# **CONSERVATION PLAN**

# HILTS/BAWDEN HOUSE 'COLDEN' TOWN OF RICHMOND HILL

### **COMMENTS**

Hilts/Bawden House 10961 Leslie Street Richmond Hill, Ontario Conservation Plan No. 12 - 8a

# **Exterior Elevations**

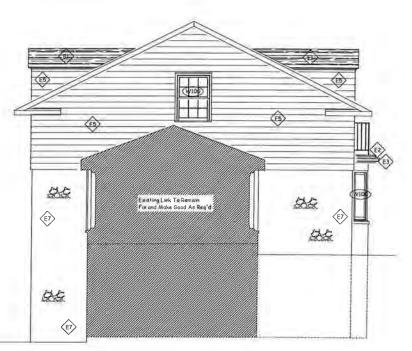
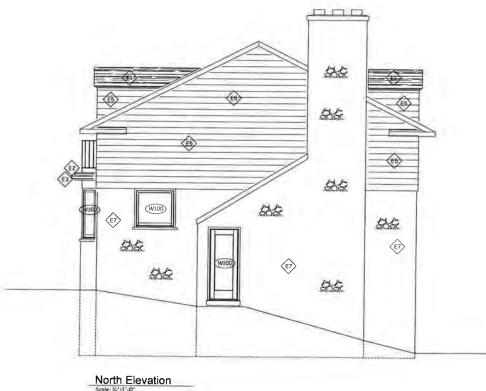
Some of the upper floor windows have exterior aluminum storm windows which are inconsistent with the heritage character of the building. Mr. Rushlow has agreed with the removal of the aluminum storm windows and their replacement with traditional wood storms. He is in the process of preparing such drawings.

- 1. The provision of drawings for traditional wood storm windows for the upper floor windows, and
- 2. The attachment of these comments to the Conservation Plan.
